Access Compliance Report

Public Rights-of-Way

(Curb Ramps)

Intersection ID: 14567	Main Street: E_TREMONT_AV	Cross Street: LYNDHURST_AV	Location:	N
ADA ID: 54F3F4286FCD	Ramp Type: PerpDiag	Initial Pass/Fail: Fail	Overall Compliance: No	Severity Score: 26.25

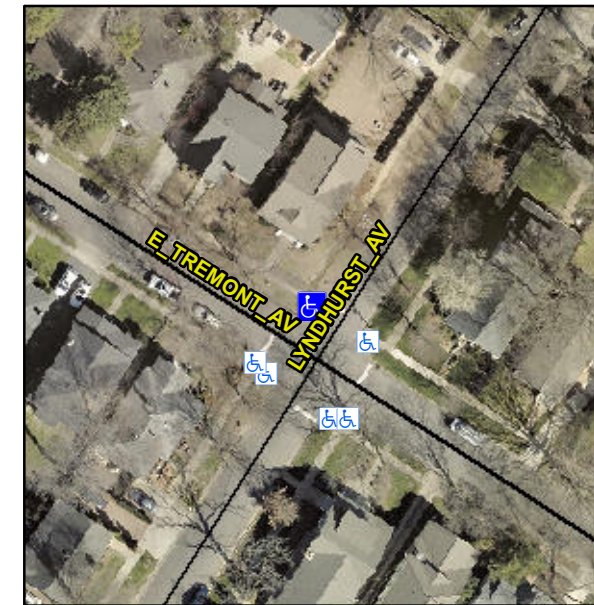
Not Found, R304.2.2, R304.5.3

Compliance	Description	Data	Compliance	Description	Data
N/A	Ramp Length (in)	82.0	No	Ramp Slope (%)	12.2
Yes	Ramp Width (in)	48.0	No	Ramp XSlope (%)	3.3
N/A	Flare Type LT	N/A	N/A	Flare Type RT	N/A
N/A	Flare Slope LT (%)	N/A	N/A	Flare Slope RT (%)	N/A
N/A	Flare Traversable LT?	N/A	N/A	Flare Traversable RT?	N/A
N/A	Landing Length (in)	N/A	N/A	DWS Provided?	N/A
N/A	Landing Width (in)	N/A	N/A	DWS Contrast?	N/A
N/A	Landing Slope (%)	N/A	N/A	DWS Length (in)	N/A
N/A	Landing X Slope (%)	N/A	N/A	DWS Full Width?	N/A
N/A	Landing Curb? (Y/N)	N/A	N/A	DWS Offset (in)	N/A
N/A	Shared Landing?	N/A			
N/A	Gutter Ponding?	N/A	N/A	Gutter Slope (%)	N/A
N/A	Gutter Lip Ht (in)	N/A	N/A	Gutter X Slope (%)	N/A
N/A	Painted X Walk1?	No	N/A	Painted X Walk2?	No
	X Walk 1 Direction	To SW		X Walk 2 Direction	To SE
N/A	X Walk 1 Width (in)	N/A	N/A	X Walk 2 Width (in)	N/A
	X Walk 1 Slope (%)	9.4		X Walk 2 Slope (%)	1.8
	X Walk 1 X Slope (%)	0.2		X Walk 2 X Slope (%)	0.5

Remove & Replace Curb Ramp With Two New Directional Ramps or Equivalent.
